Bid No. 24-214  
**ADDENDUM NO. 5**

**San Mateo-Foster City School District  
Bowditch Middle School  
Academic Quad Bidding with Gymnasium Building  
(Also Known As: Academic Core and Gym)**

Date: 22 December 2023

Project: Bowditch Middle School  
Academic Quad and Gymnasium Building  
1450 Tarpon Street  
Foster City, CA 94404

14 ROLLER SHADE - INTERIOR WINDOW  
3" = 1'-0"

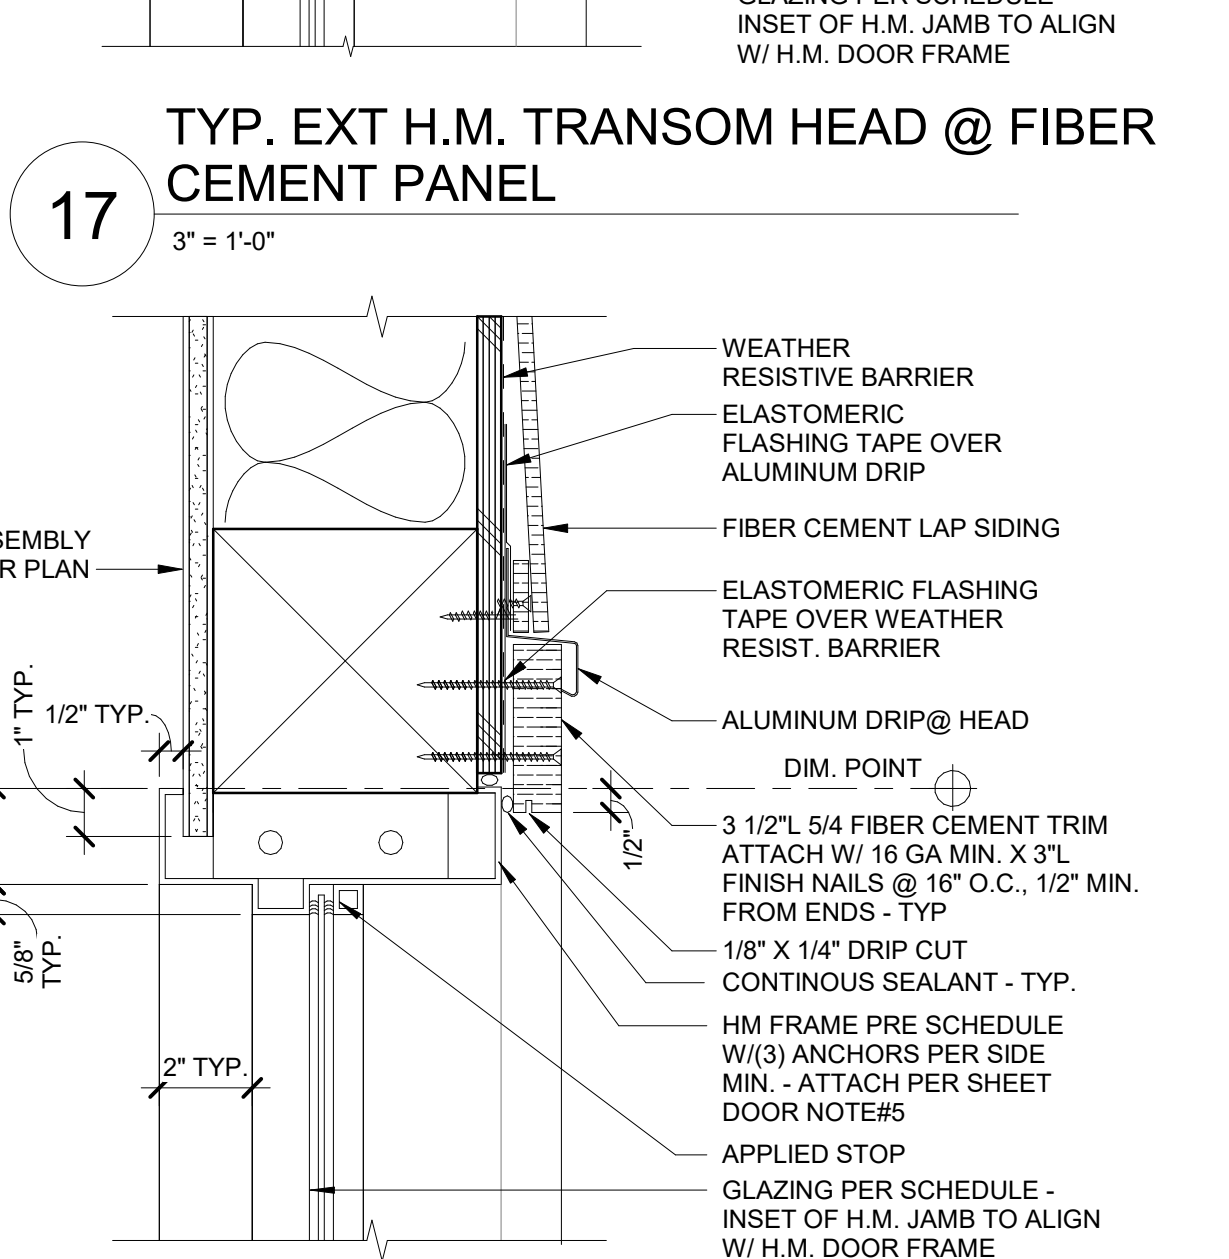
5. See attached Sheet A-102. Add keynote 2.05 which reads 'MOTORIZED ROLLER SHADE AT INTERIOR STOREFRONT – SEE DETAIL 14/A-552'. This note applies to window type W5 at (2) interior opening locations .in QUIET AREA 01.

13 INTERIOR STOREFRONT DOOR JAMB (HEAD SIMILAR)  
3" = 1'-0"

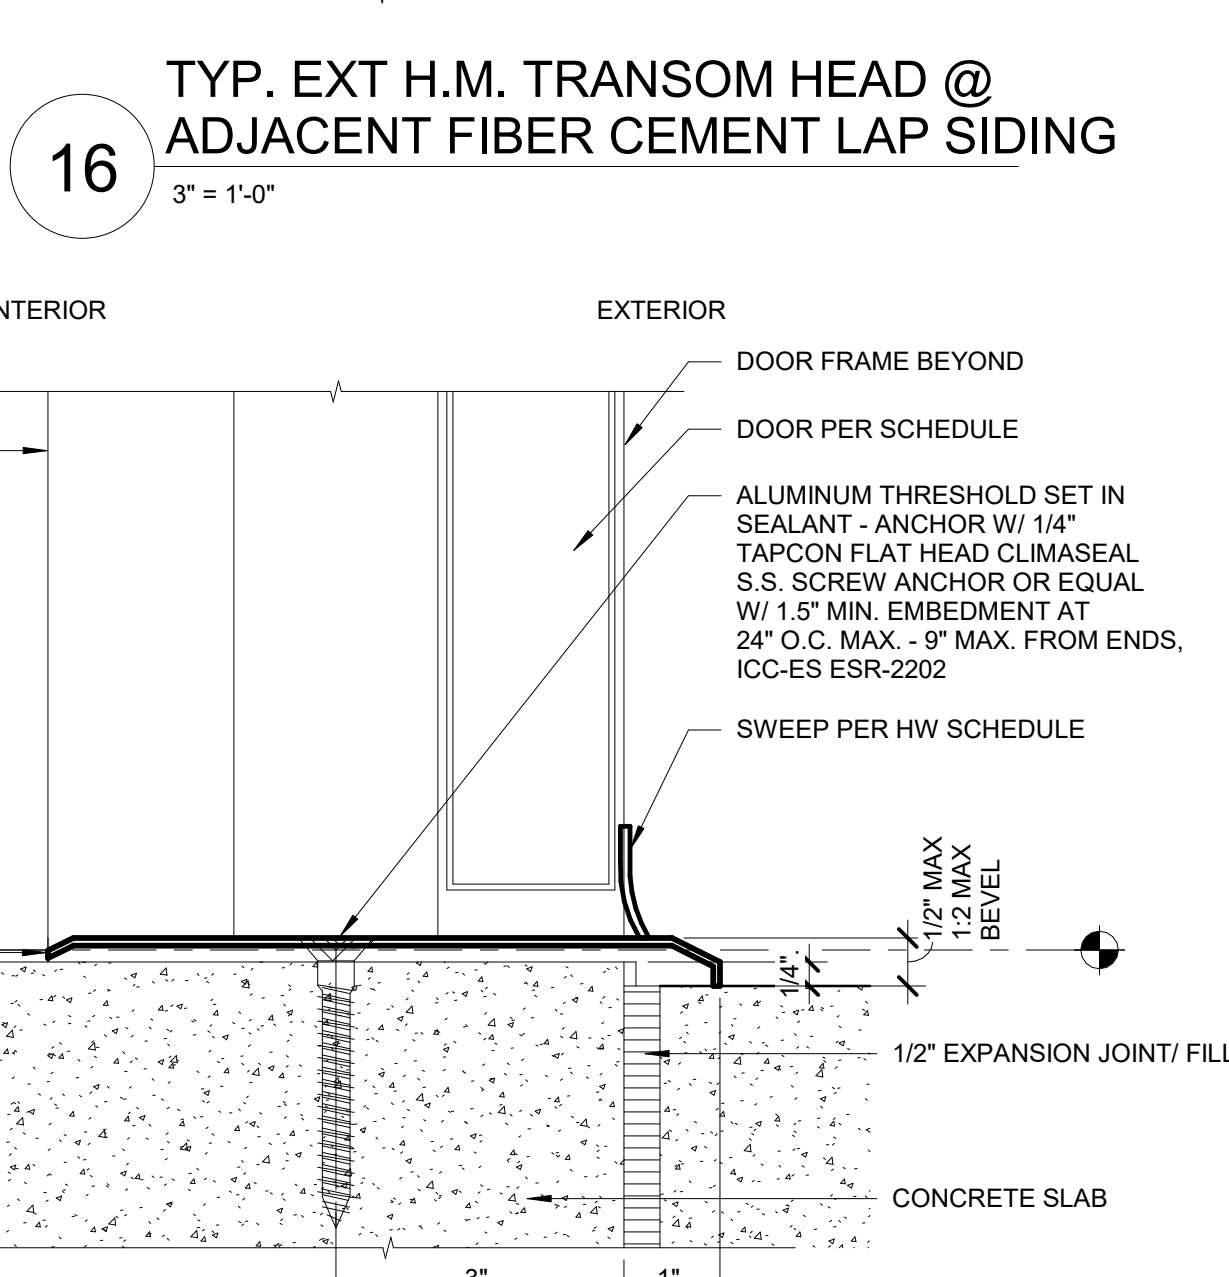
1. See attached sheet A-585: Revise to 4 the detail number for 'TYP. FLOOR TRANSITIONS'.
2. See attached detail 13/A-552 – add note 'HEAD SIMILAR' to detail titled INTERIOR STOREFRONT DOOR JAMB.

W5 INTERIOR FIXED ALUMINUM STOREFRONT

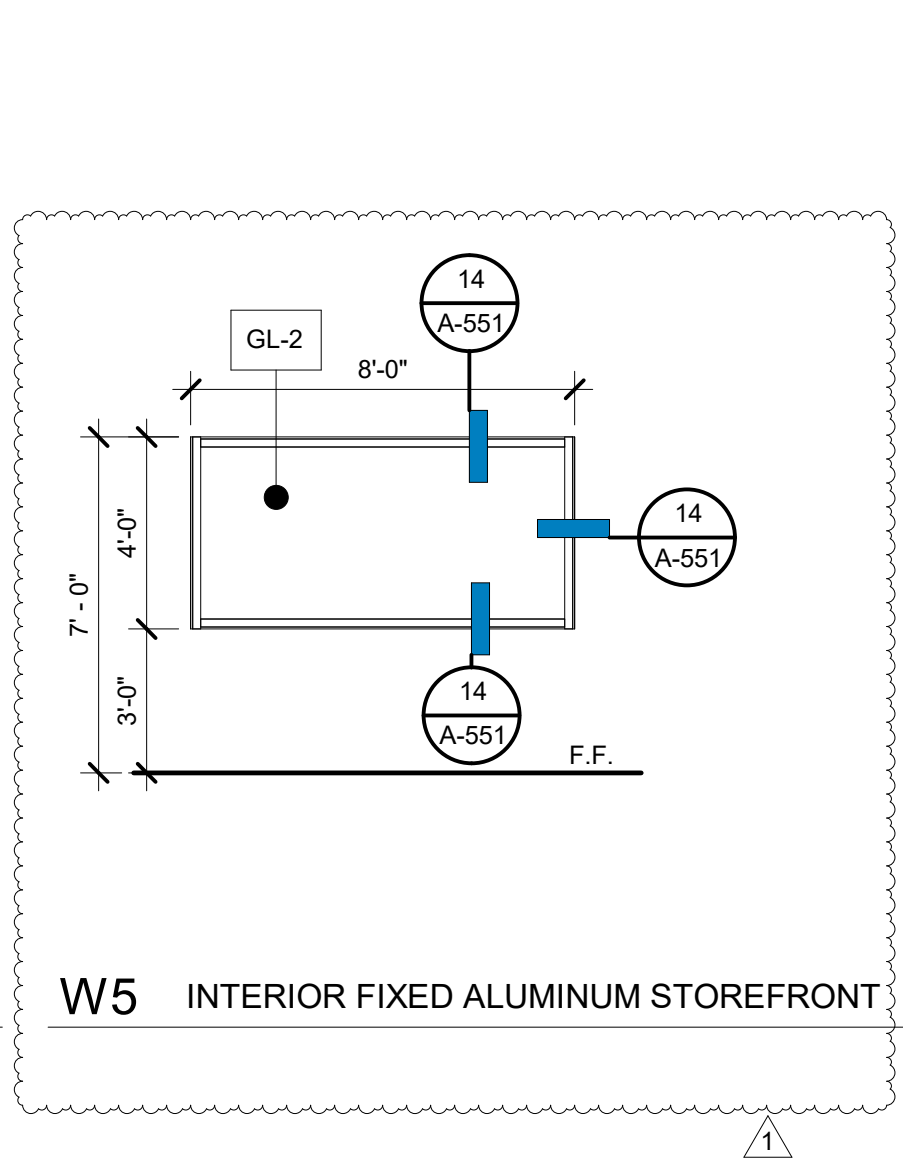
4. See attached Sheet A-602 Window type W5. Revise to an aluminum storefront opening. Reference HEAD / JAMB detail 12/A-552. Reference Sill detail 10/A-552.
